**FINAL DRAINAGE REPORT FOR
BRADLEY POINT FILING NO. 1

EL PASO COUNTY, COLORADO**

APRIL 2023

Project #70-074
PCD Project # MS-21-002

North Pond: 5 YR Inflow and Outflow Hydrographs

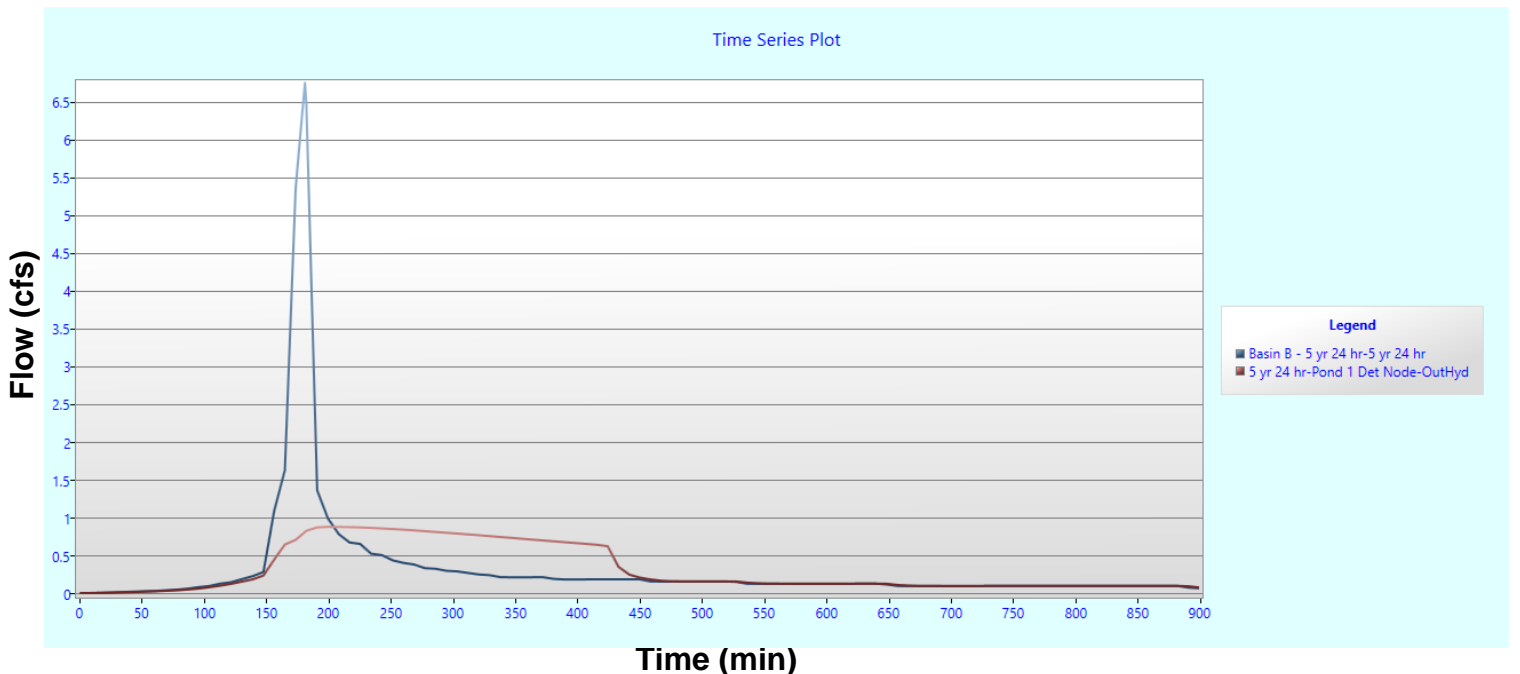
Address flows going through the spillway (overtopping) and flows being infiltrated. (See comment letter)

PROPOSED DRAINAGE MAP

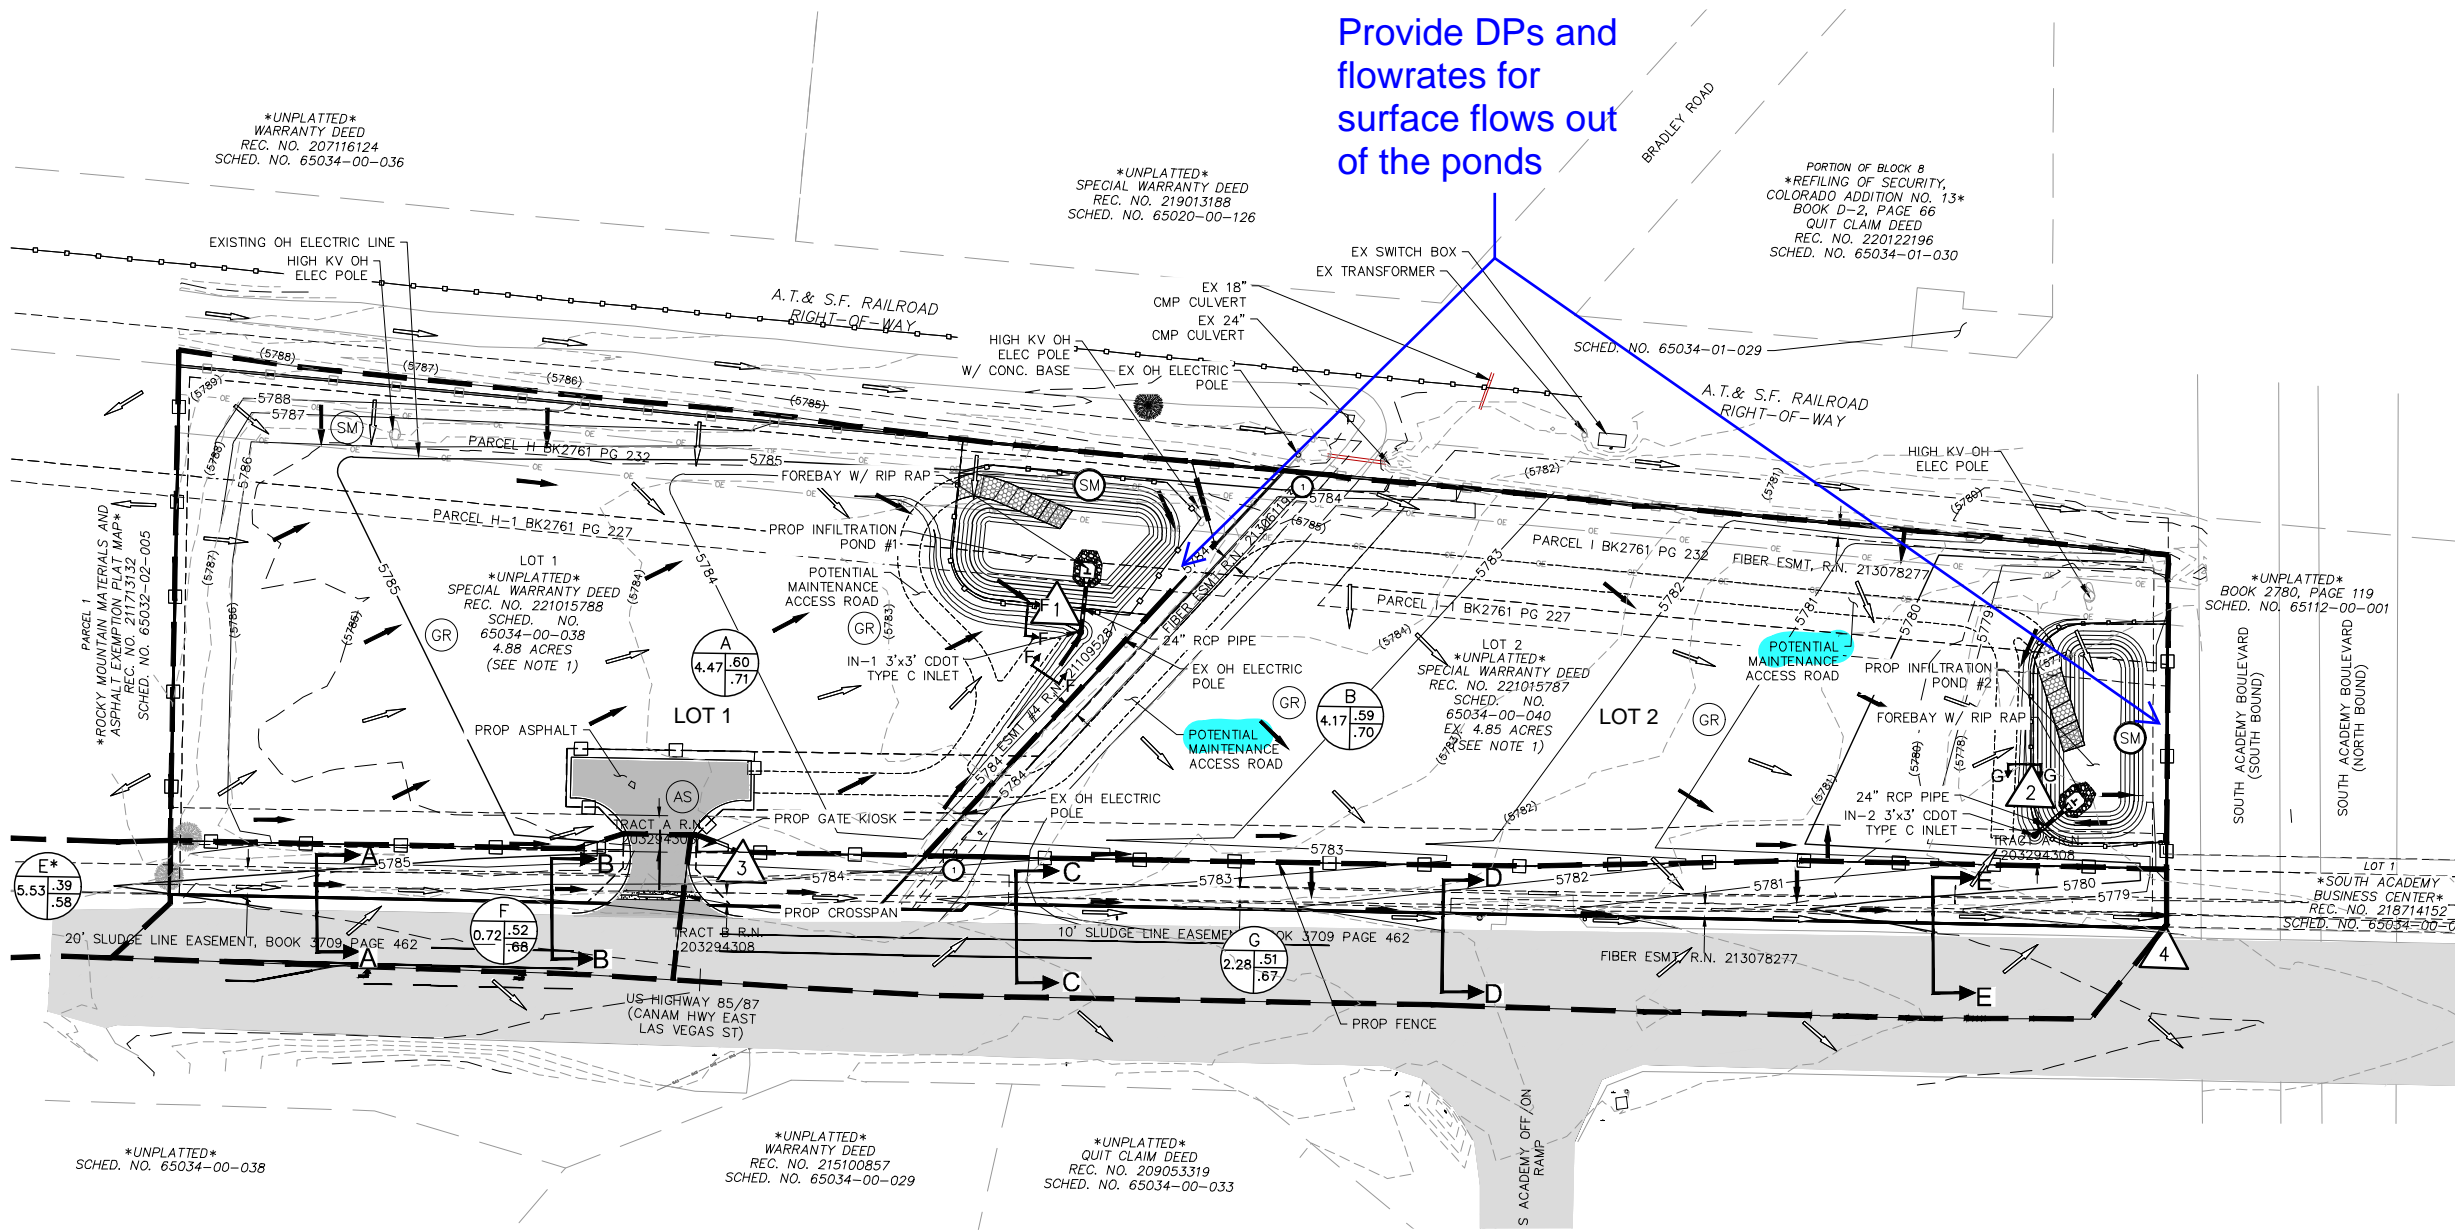
Provide DPs and flowrates for surface flows out of the ponds
